Report
Project: 125506-6.4.3

PATHWAYS PHASE 3 - BLOCK 60 SERVICING BRIEF

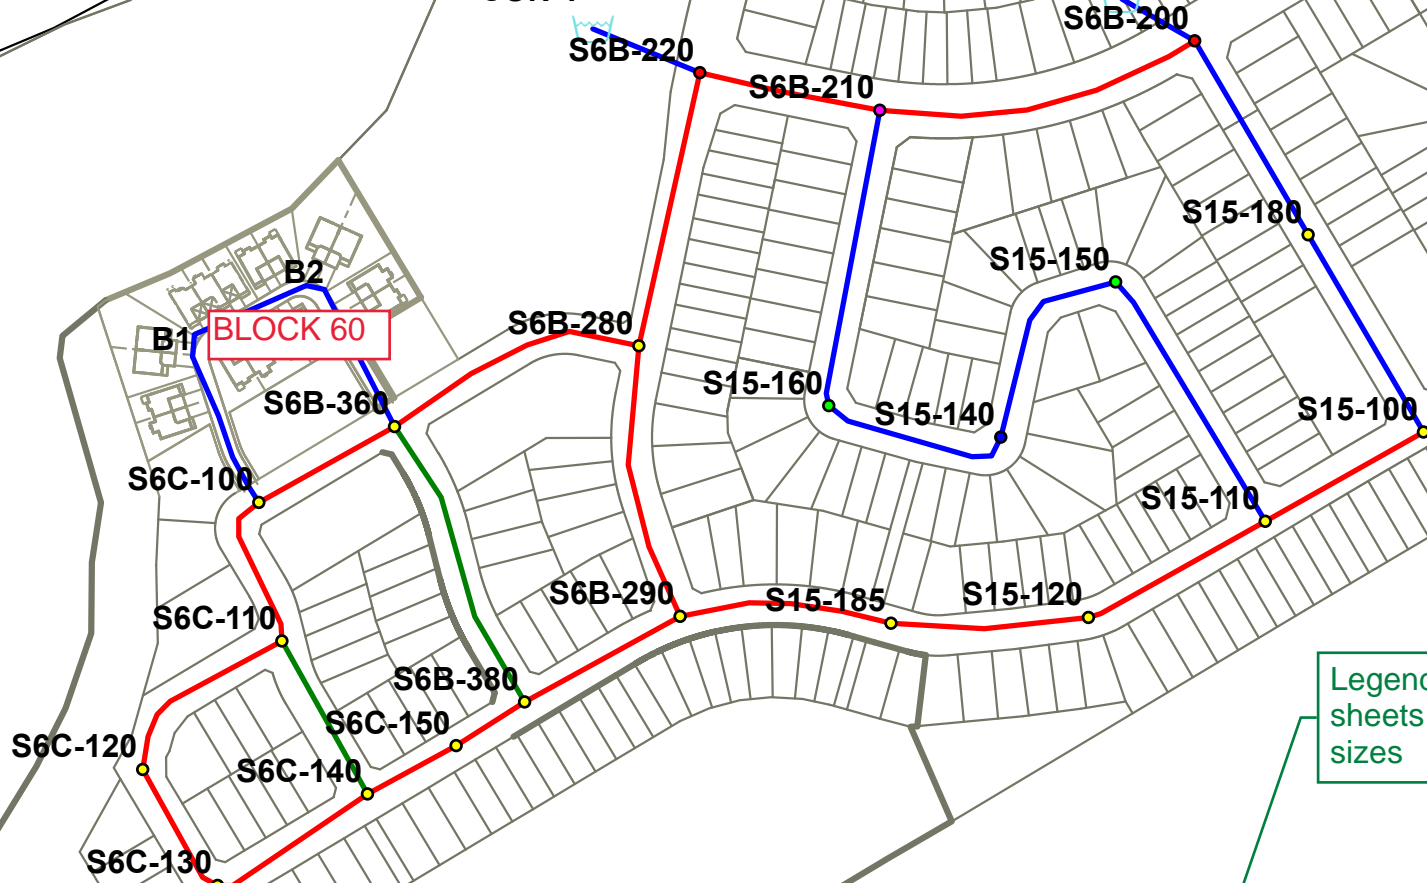
REPEAT COMMENT:
Please provide legend to the figures
